RESPONSE TO COMMENTS

Re: Waterstone Site Plan No 4, DA-1758-10, 4th submittal comments

Please accept this letter in response to your December 2024 review comments on the Waterstone Site Plan No 4, DA-1758-10, 4th submittal comments.

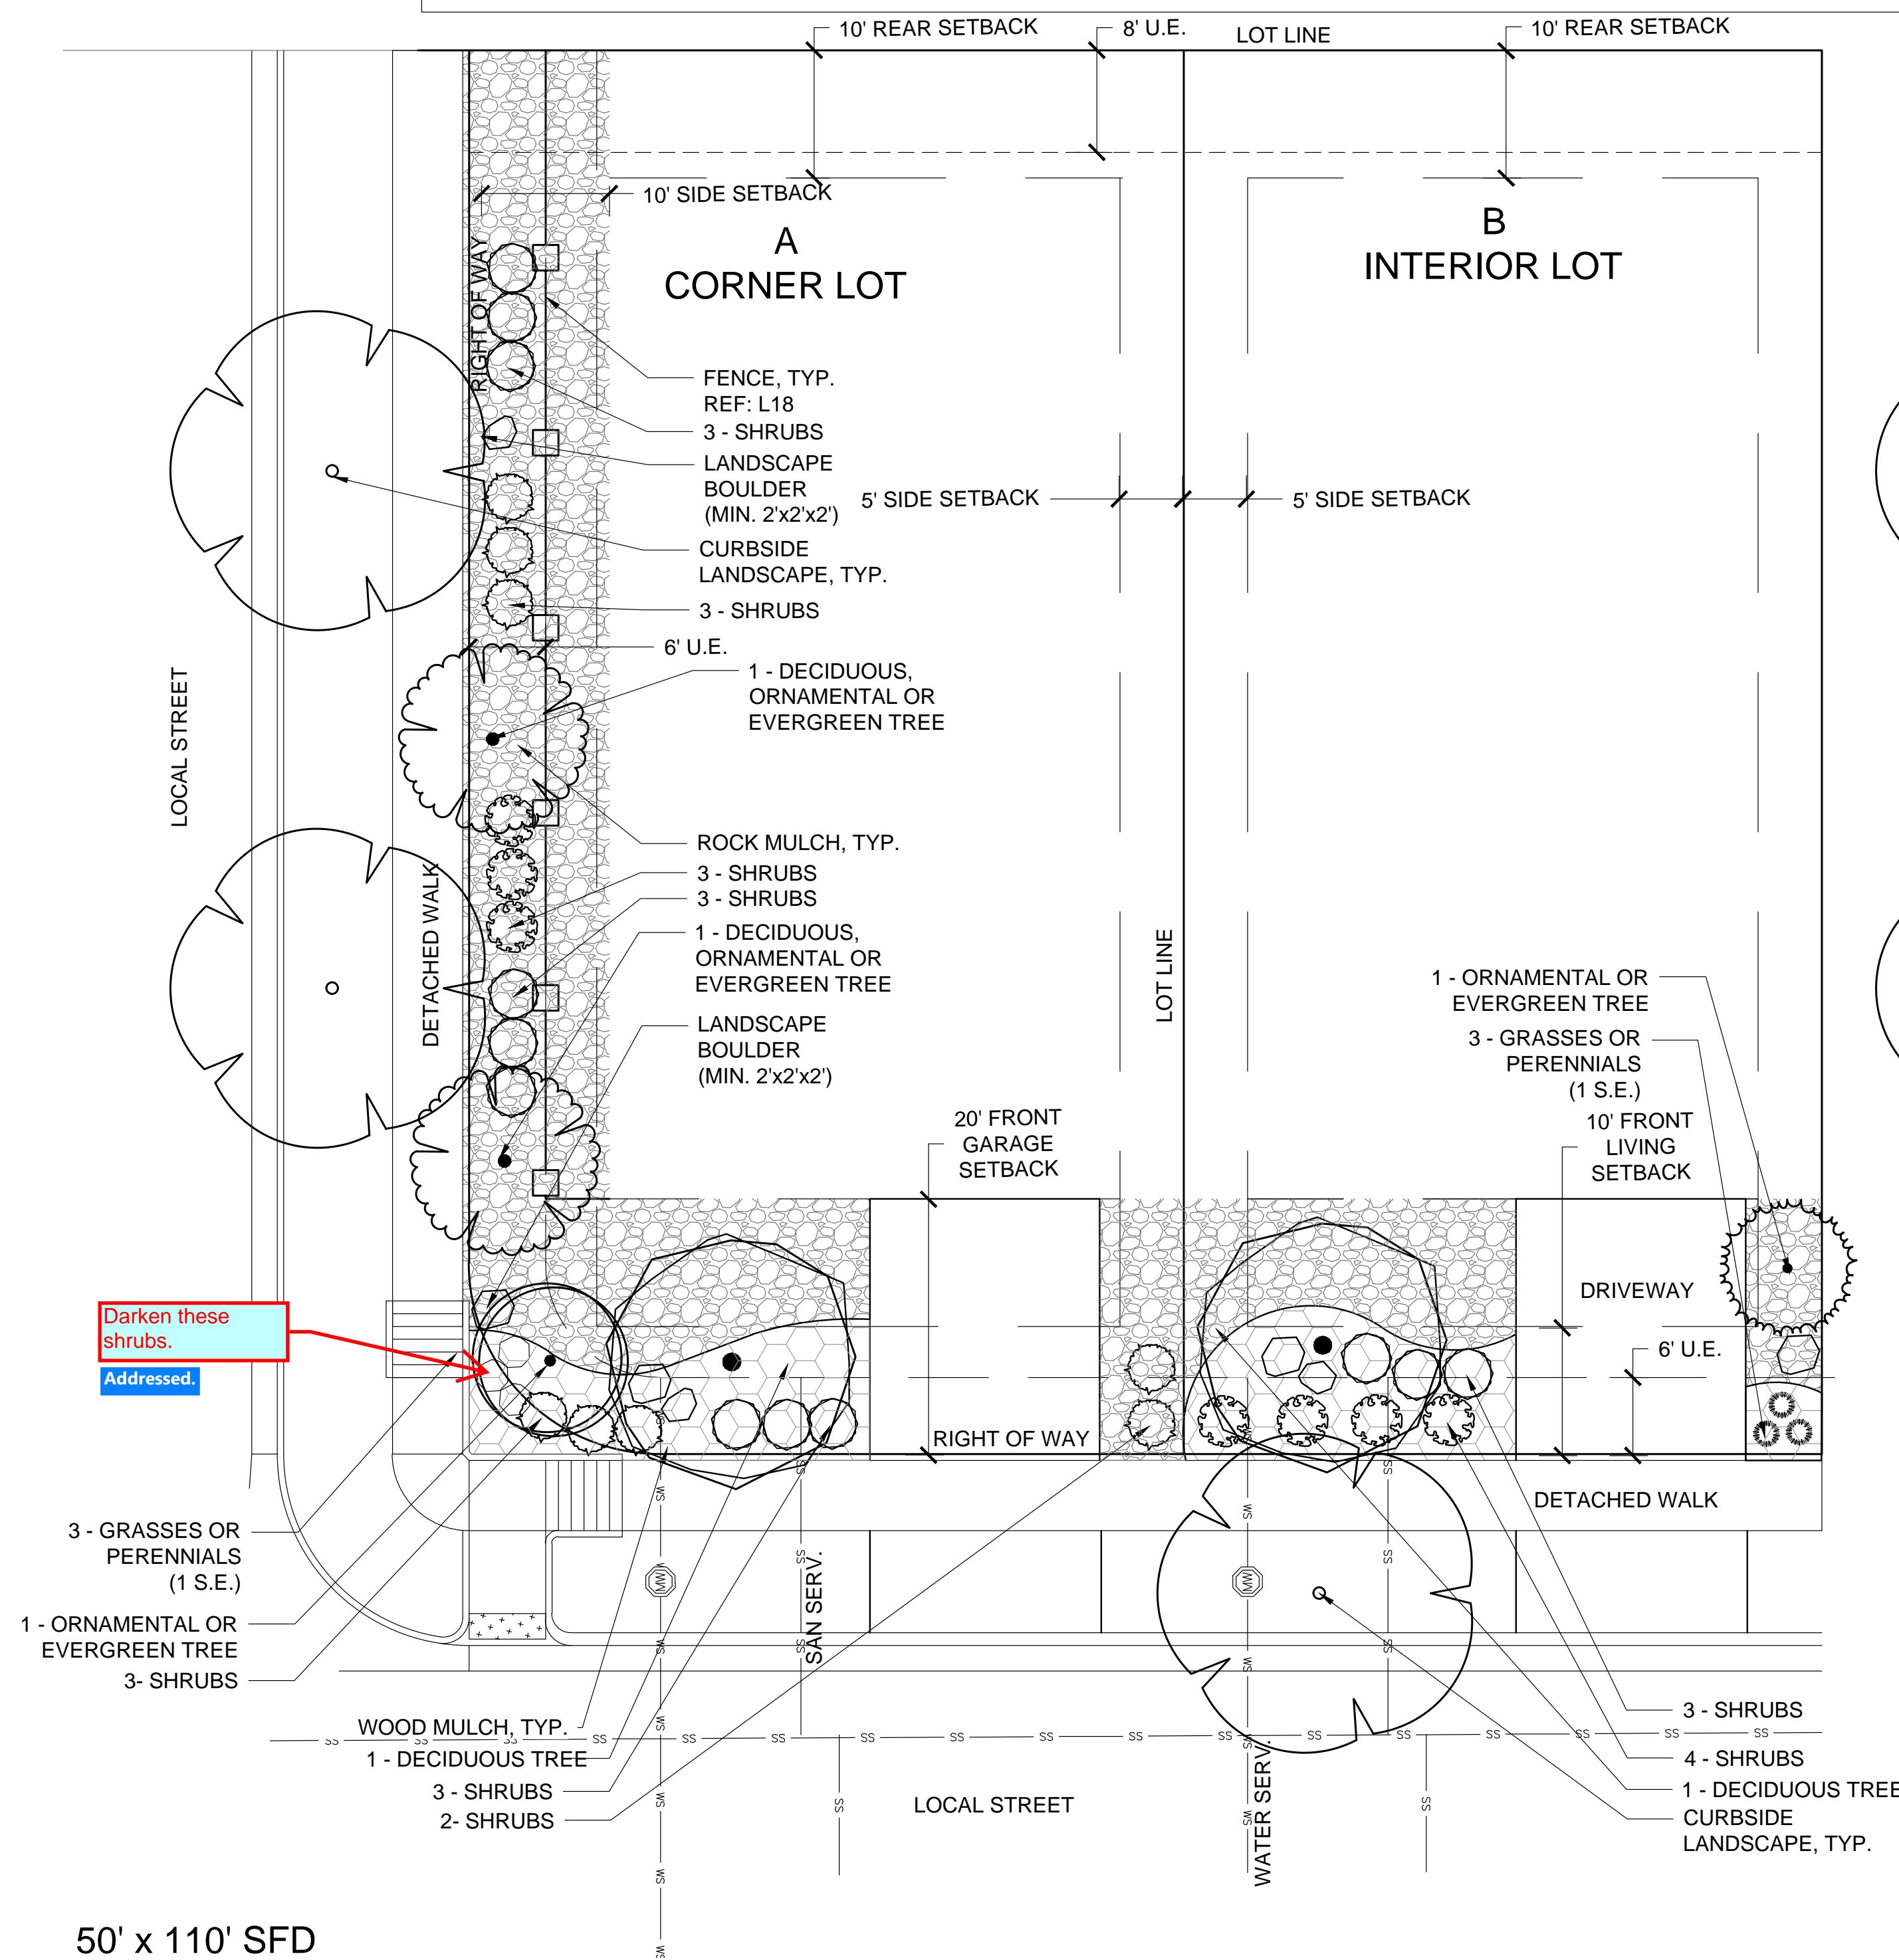
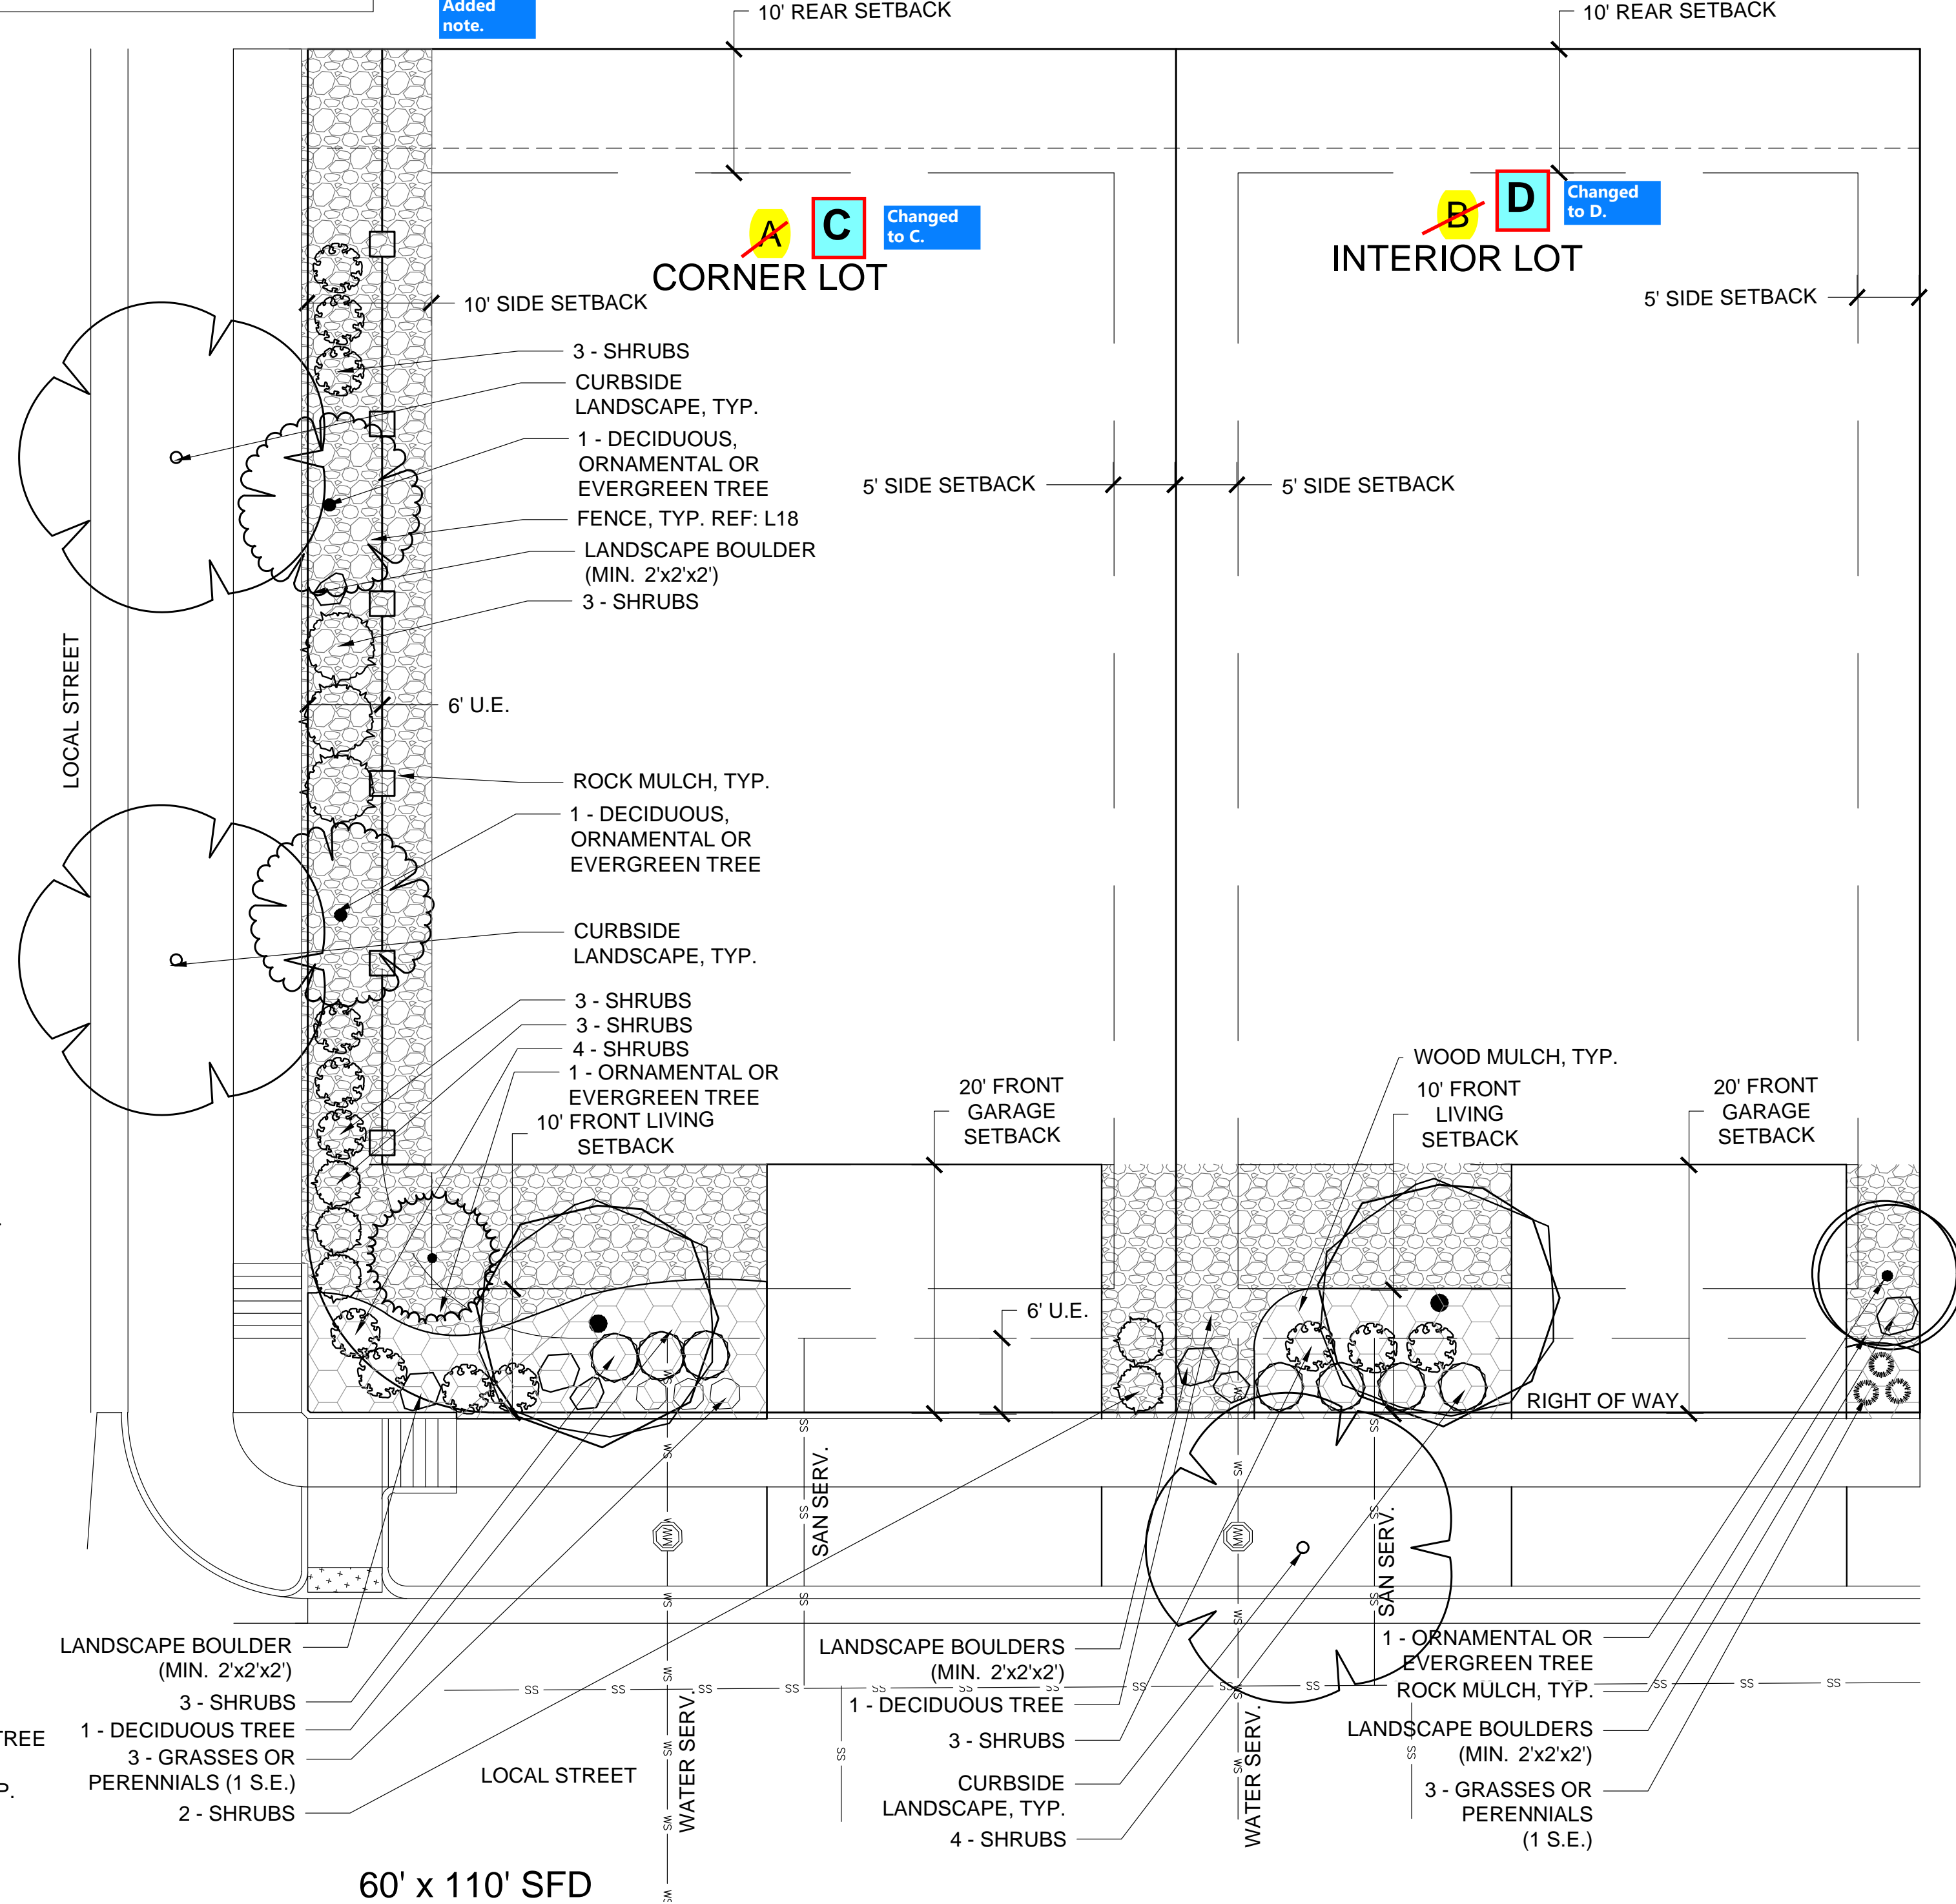
Add: Plant schedule for front yard landscaping can be found on Sheet 19.

Added note.
